File: A156/21

Address: 49 Michael Ct Thornhill

**Minor Variance
Application**

Staff Report Prepared By: Pravina Attwala, Assistant Secretary Treasurer

SITE PLAN

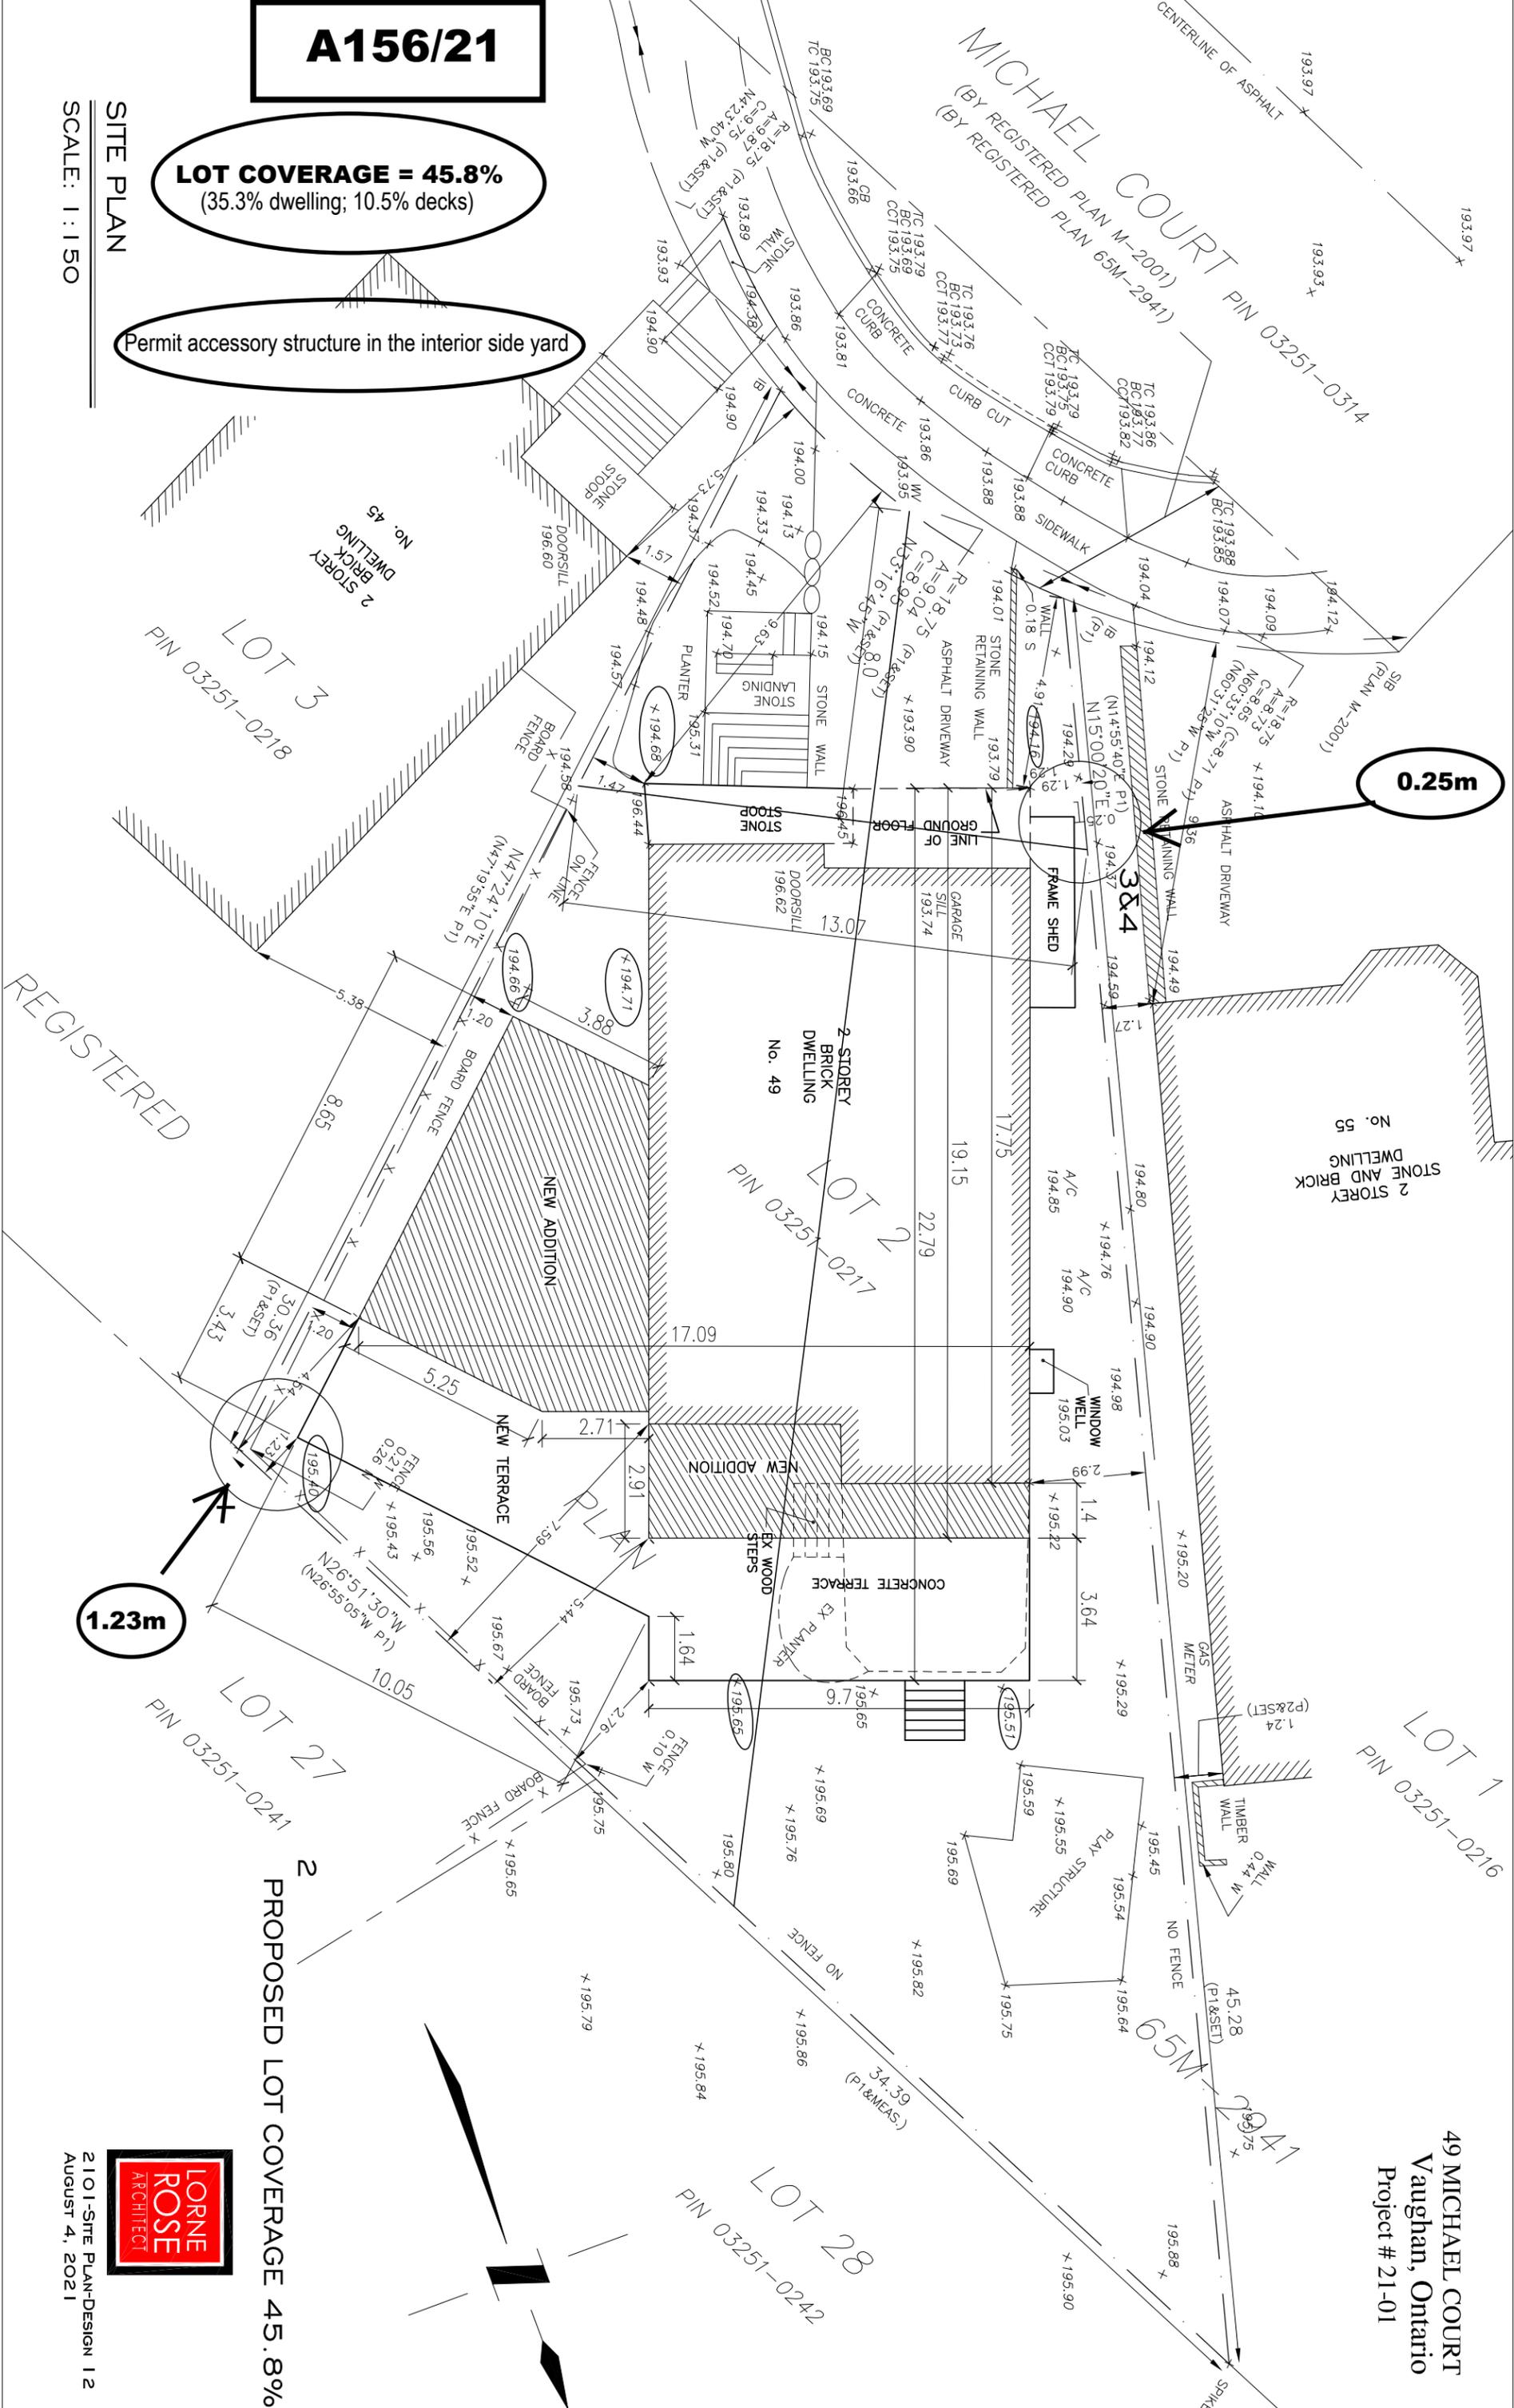
1. DP has concerns with a rear yard setback of 1.23 m (variance #1), given the concrete terrace is above grade and has a roof component that will be visible to the adjacent landowners. DP staff have analyzed similar proposals in the area and have come across two in particular noted below:

Please note that examples are only used to better understand the existing site context and does not determine the merit of this variance application. In addition, it should be noted that the above noted properties were less contentious, as their rear yard lot line did not abut other residential lots and only considered a one-storey addition. With this in mind, Development Planning strongly encourage the concrete terrace be scaled back to line up flush with the sliding door proposed for the two-storey addition (shown in the rear elevation). Planning staff is of the opinion that reducing the width and depth of the terrace will directly improve the rear yard setback to a distance planning can support.

Given that the neighbor at 55 Michael Court has confirmed that there are no ponding or other issues because of the decreased setback of the side yard shed, the Development Engineering (DE) Department does not object to variance application A156/21.

2. The Development Planning Department is working with urban design staff to implement a condition of approval that will require the Owner implement screening (vegetation) and/or remove the windows on the east side of the addition. Their comments are forthcoming and have been delayed as staff are currently away from the office and will be returning early next week

The Owner/applicant shall submit the final Lot Grading and/or Servicing Plan to the Development Inspection and Lot Grading division of the City’s Development Engineering Department for final lot grading and/or servicing approval prior to any work being undertaken on the property. The owner/applicant shall demonstrate the appropriate LID (Low-impact Development) measures and include the measures in the lot grading drawing to the satisfaction of DE to mitigate the impacts of additional storm runoff. Please visit or contact the Development Engineering Department through email at DEPermits@vaughan.ca or visit https://www.vaughan.ca/services/residential/dev_eng/permits/Pages/default.aspx to learn how to apply for lot grading and/or servicing approval.
